RIDGE PORT 3RD ADDITION

RE: S/D 99-84 -- Final Plat of RIDGE PORT 3RD ADDITION

STAFF REPORT
(Final Plat, Overall Preliminary Plat Approved 10/21/99)

CASE NUMBER: S/D 99-84 -- RIDGE PORT 3RD ADDITION

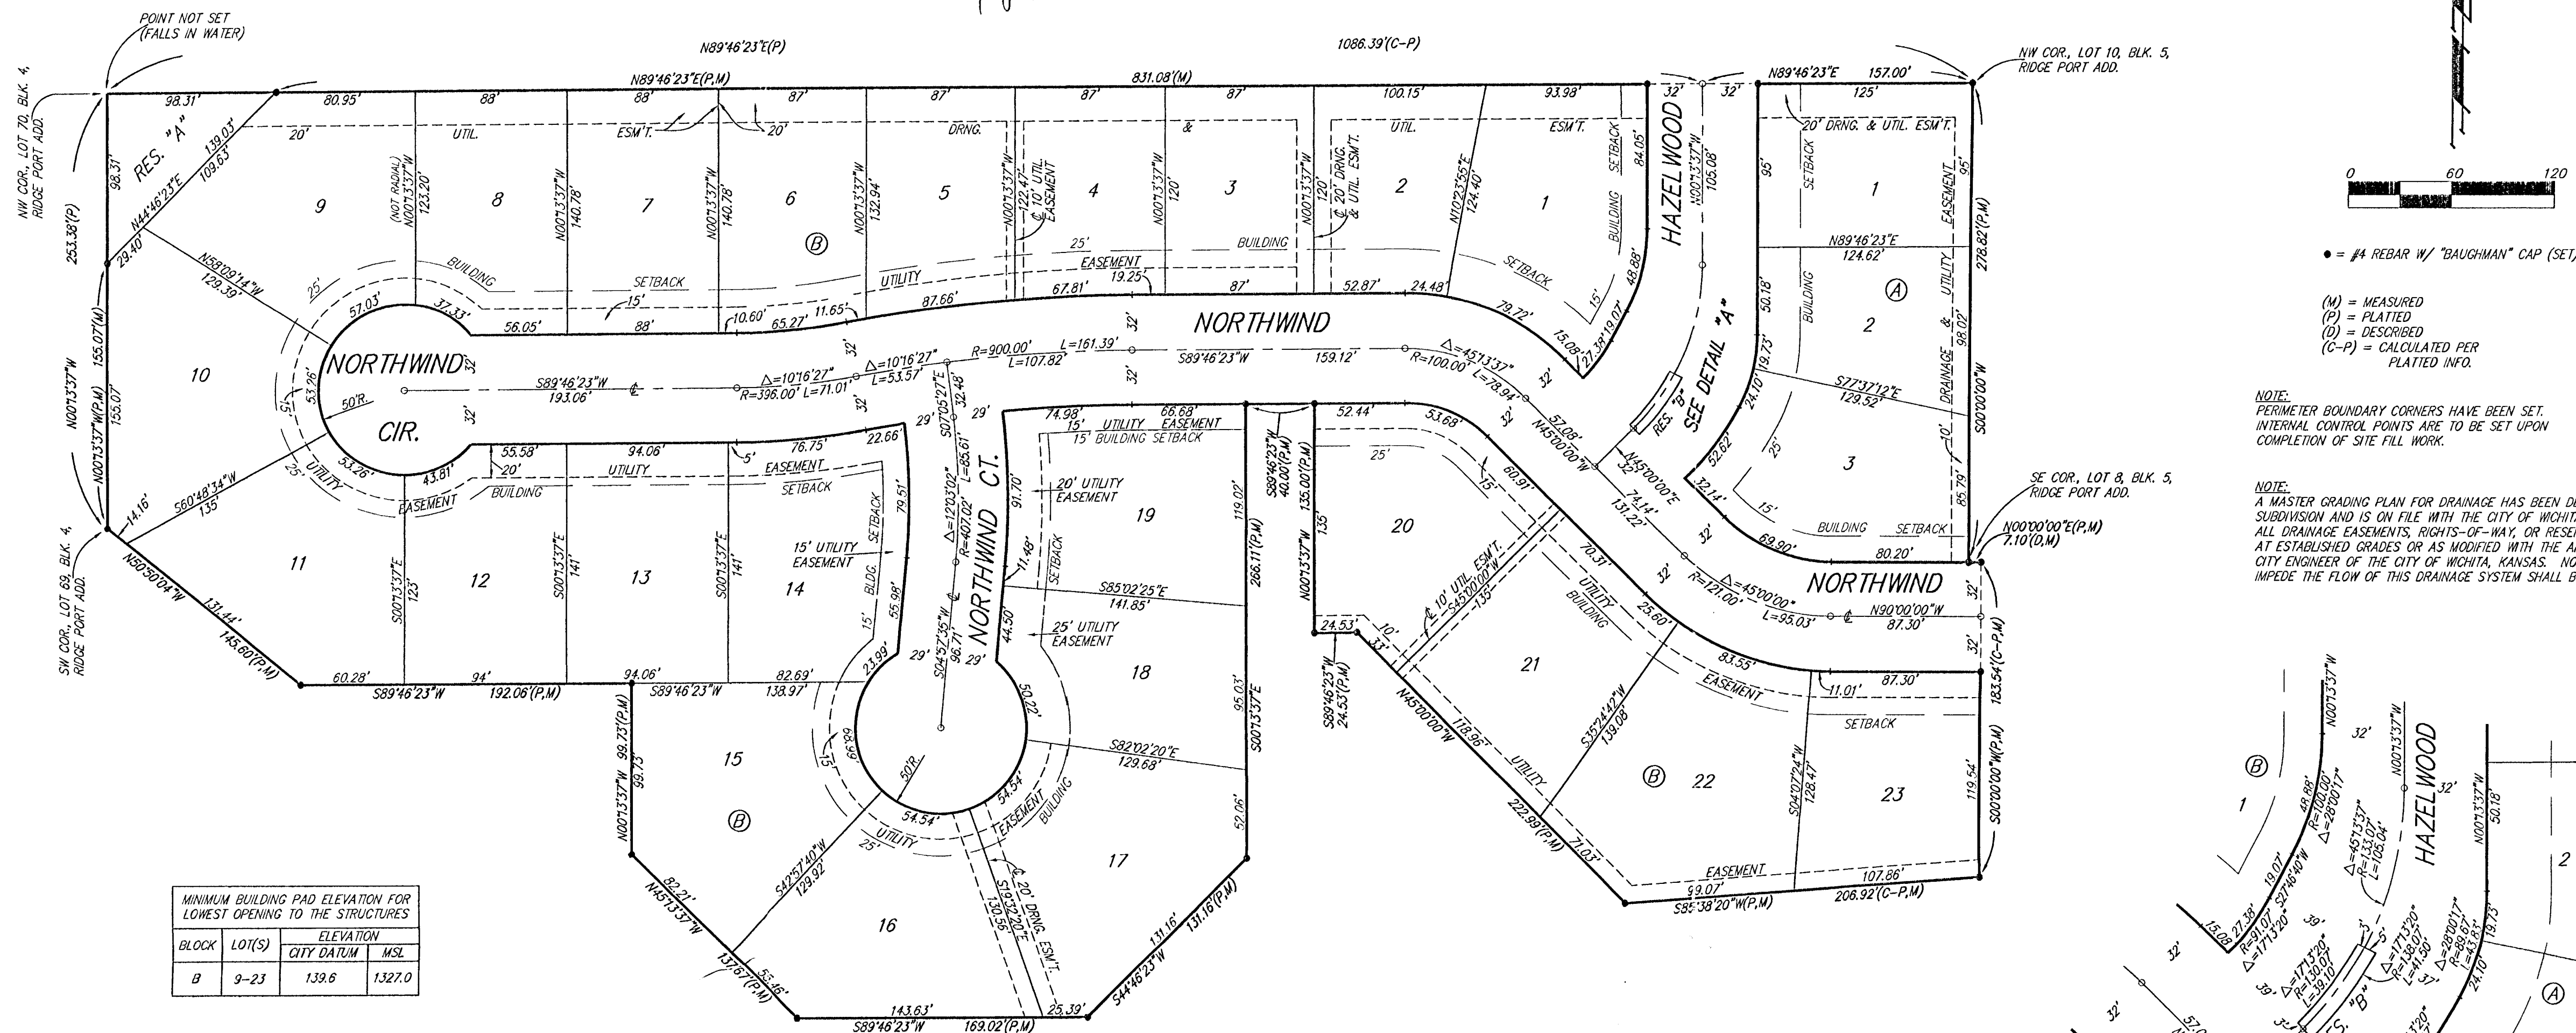
- F. City Fire Department needs to comment on the plat's street names. *The final plat tracing needs to indicate the following street name changes: Northwind Court to Northwind Circle, Northwind Circle to Northwind Court.*

- S. The representatives from the utility companies should be prepared to comment on the need for any additional utility easements to be platted on this property. ***KGE and Southwestern Bell have requested additional easements which have been denoted on the final plat.***
- T. The applicant is reminded that a disk shall be submitted with the final plat tracing to the Planning Department detailing this plat in digital format in Release 13 version of AutoCAD. This will be used by the City and County GIS Department.

The final plat has made the requested street name changes.
